TALLAWONG STATION **PRECINCT SOUTH**

ADDENDUM URBAN DESIGN REPORT

Rev. F_20.01.2021

AMENDMENTS TO BUILDING ENVELOPES FOOTPRINT & STOREYS

AMENDED DEEP SOIL AND BASEMENT DIAGRAM

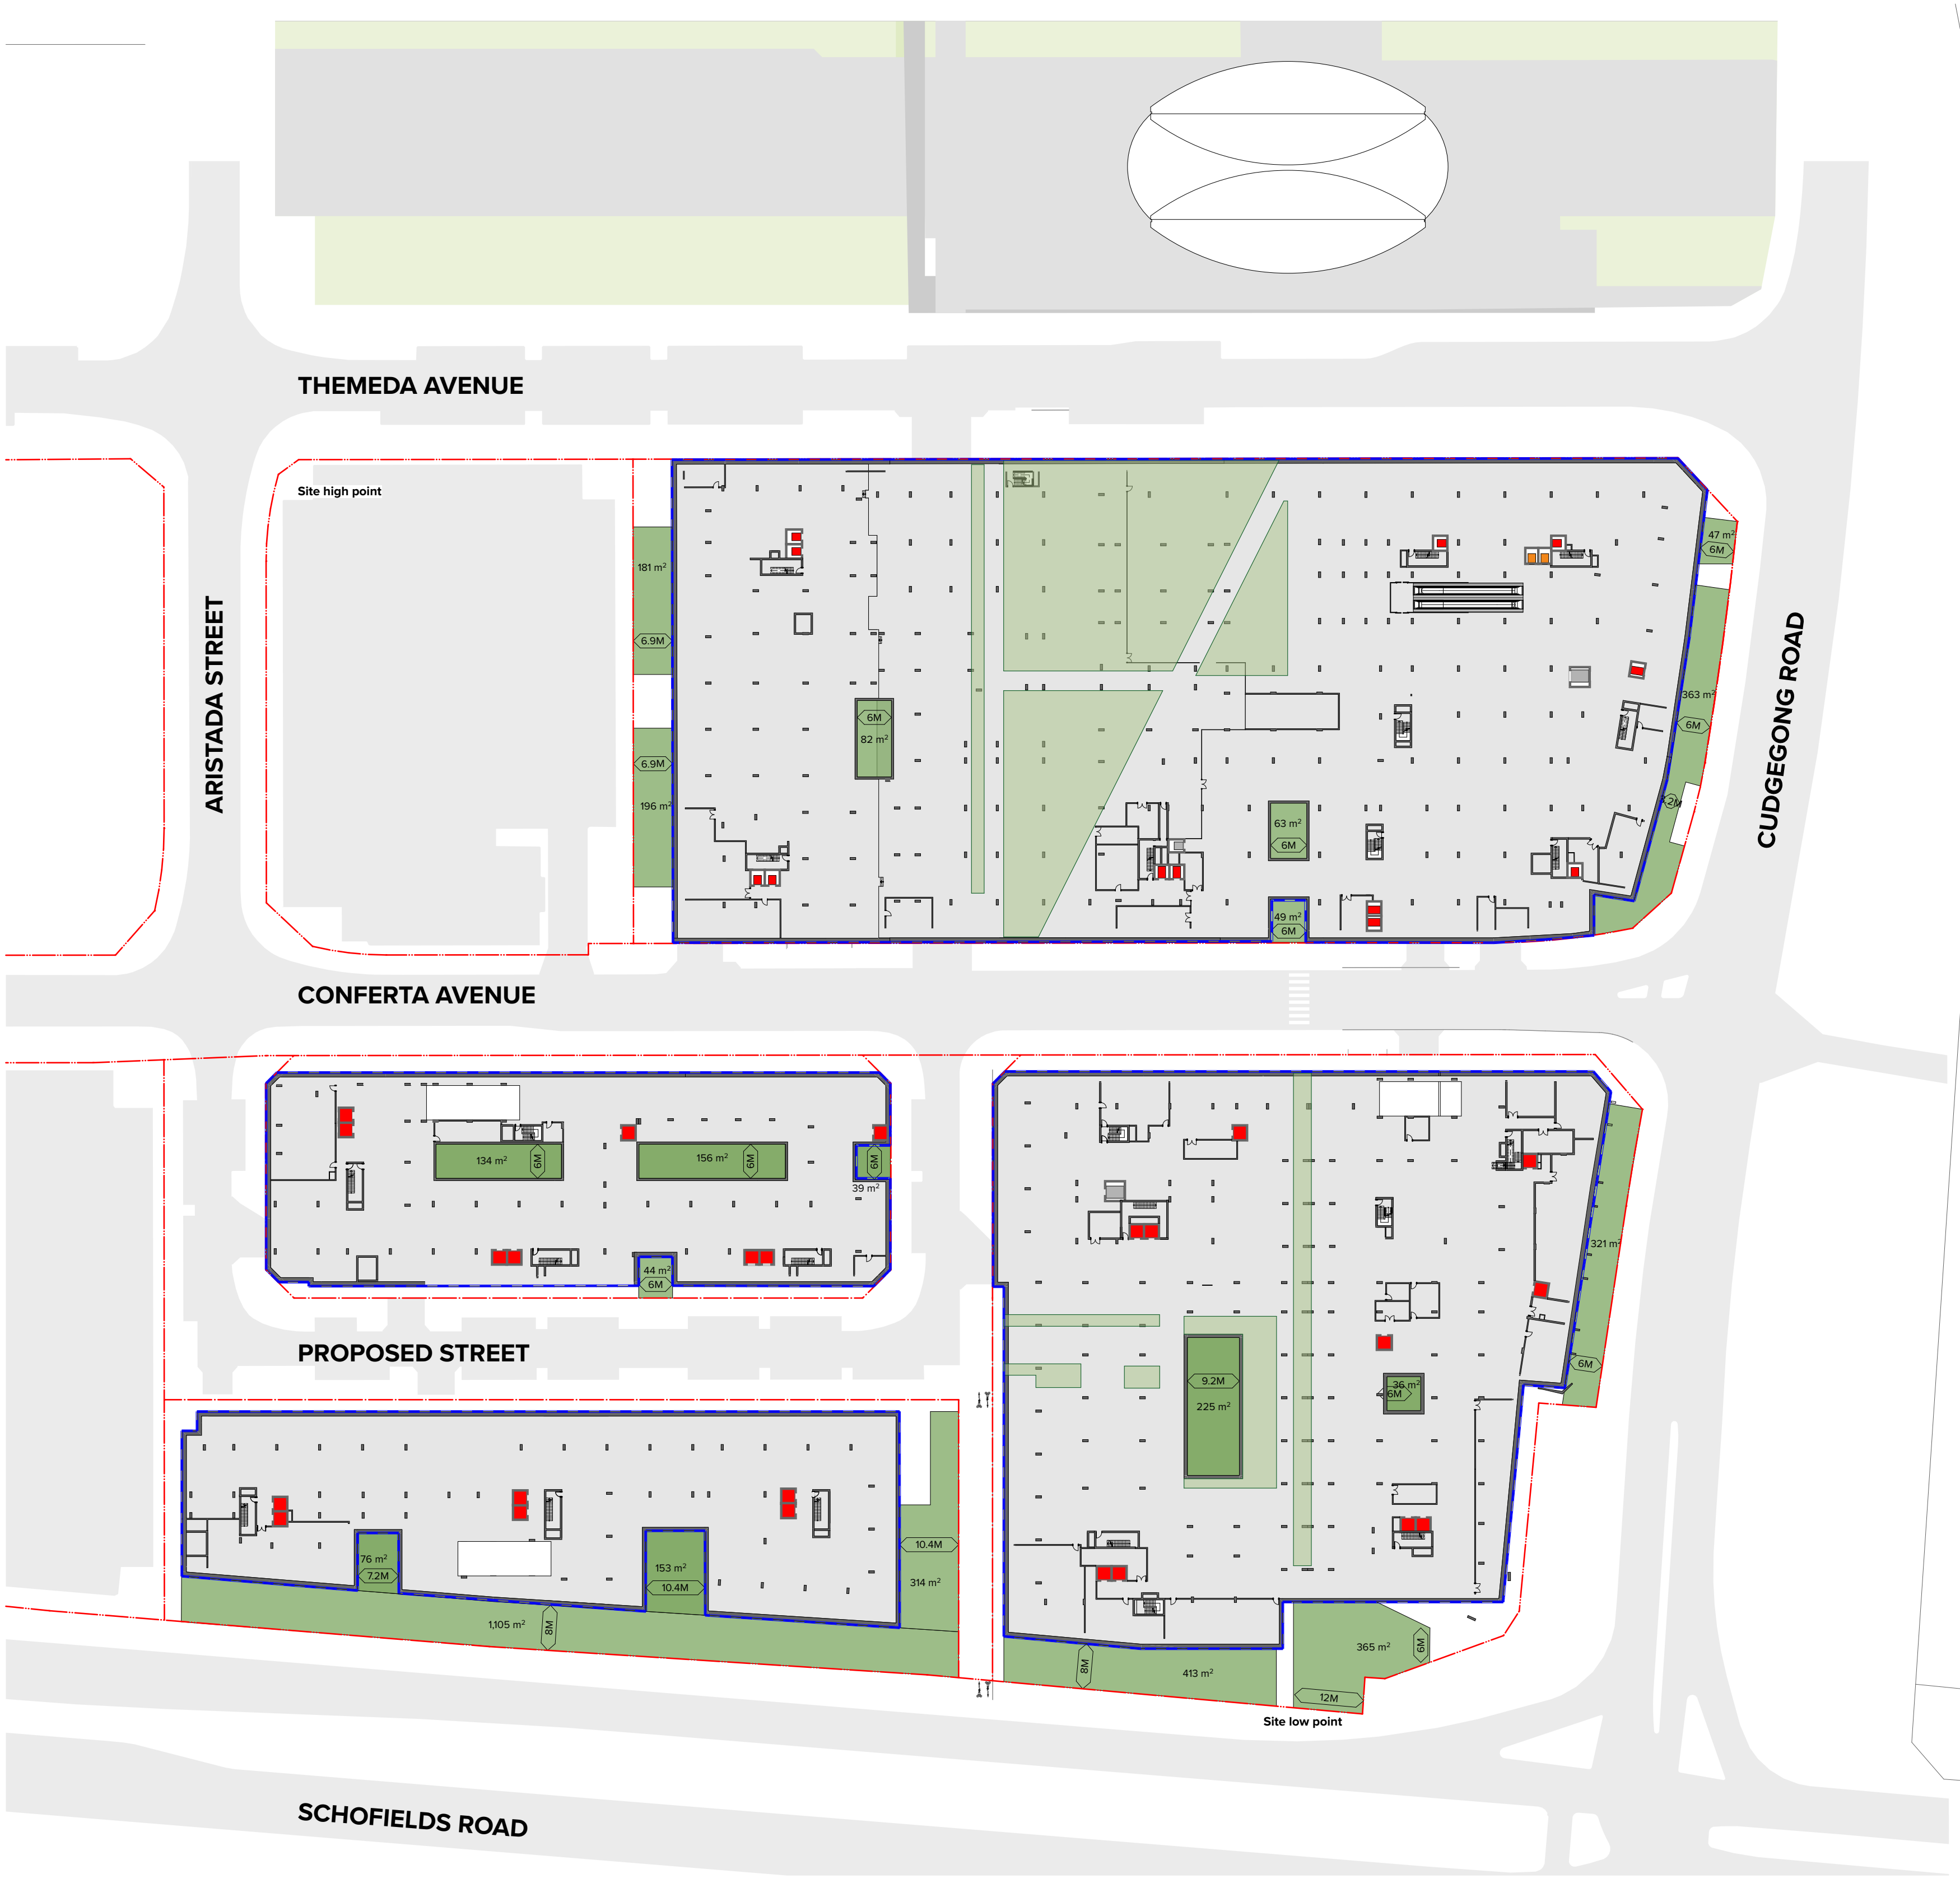
However, Council have resolved that they do not wish to take ownership of the park or the western adjacent street which is proposed to be designed as a private street. Accordingly, it is proposed that the park will be retained in private ownership and that public access of the park will be secured on title.

This provides the opportunity to extend the basement below the park which achieves a significant streetscape improvement as it facilitates the minimisation of the vehicle access points into Site 1A. In order to ensure that the park is still capable of supporting mature and generous trees and vegetation, a large soil 'vault' is proposed above the basement level with a minimum depth of 1.5 metres per detailed specialist consultant advice.

DEEP SOIL ON STRUCTURE TO PUBLIC DOMAIN

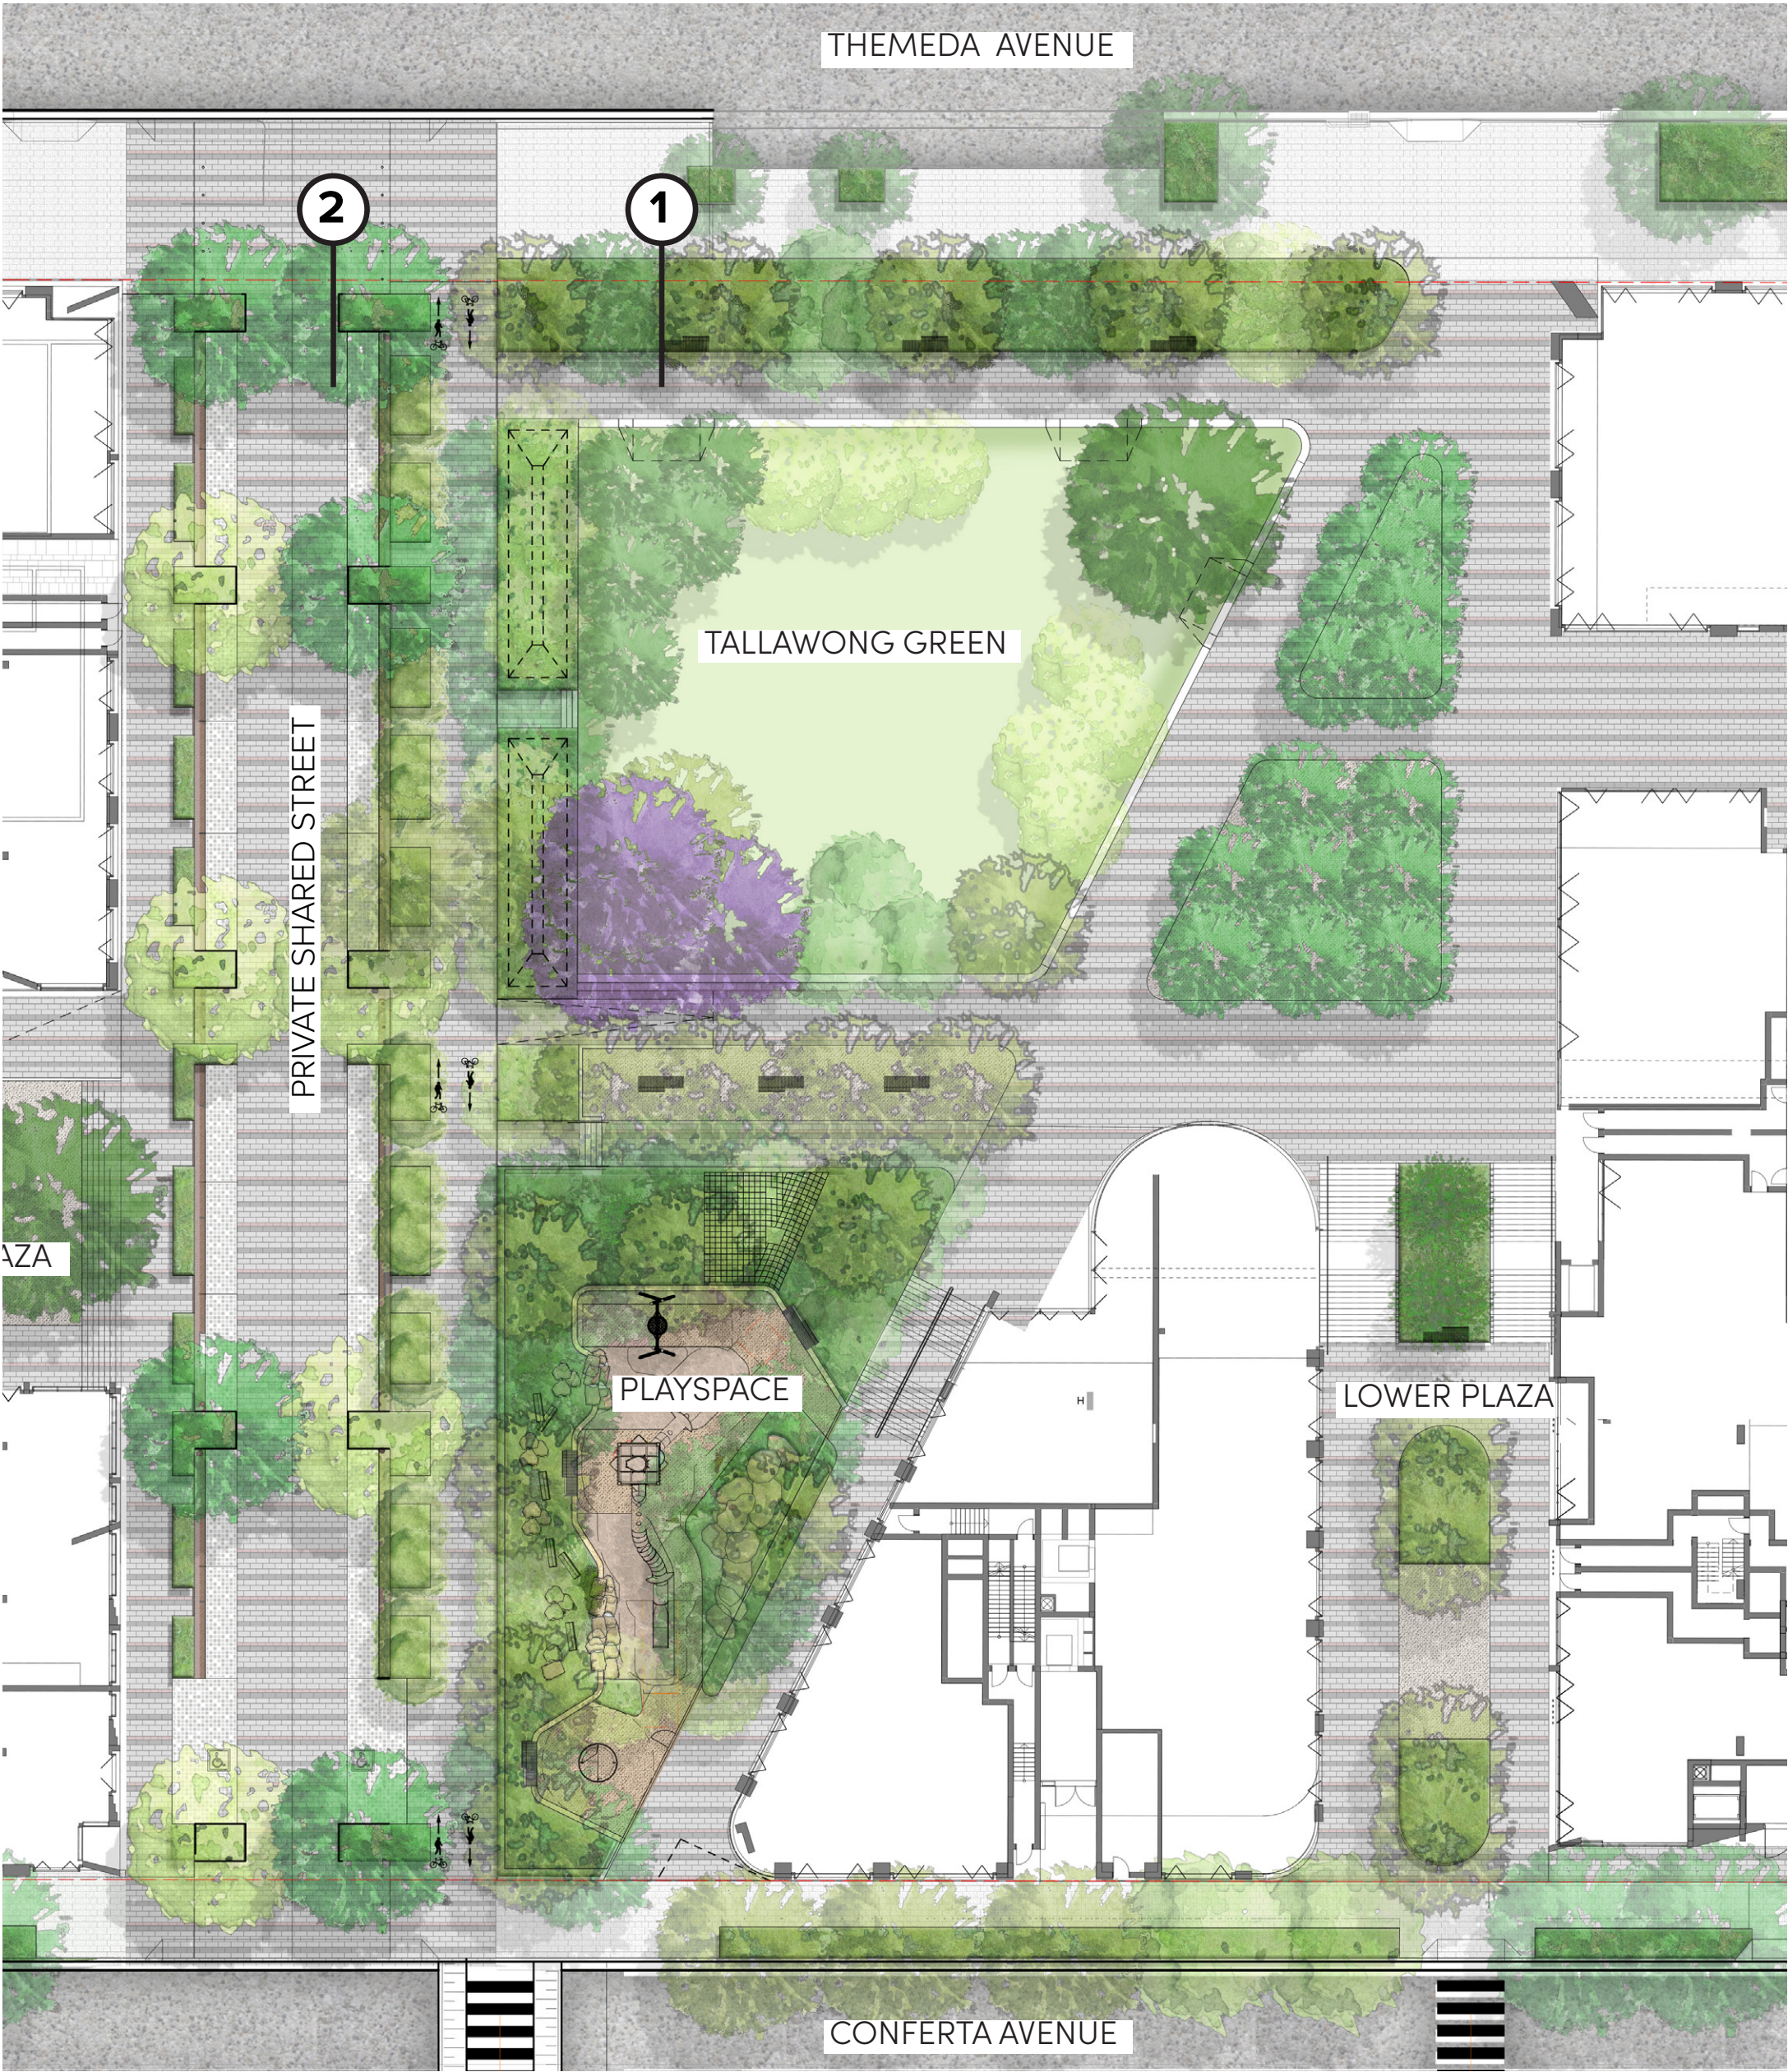
Notwithstanding the benefits of locating basement levels under the park previously detailed, there shall be no reduction in the quality, amenity or function of the park and public domain.

A soil structure analysis has been prepared by SESL Australia in support of the detailed development application to ensure there is sufficient soil depth and volume, as well as drainage and irrigation, to achieve a landscaped outcome which is not compromised.

This report concluded that an optimal depth of soil for plant and tree growth is 1.5 metres overall depth from the top of structure to the finished ground level.

Accordingly, the basement levels are to be located to achieve a soil 'vault' for the park with a minimum depth of 1.5 metres.
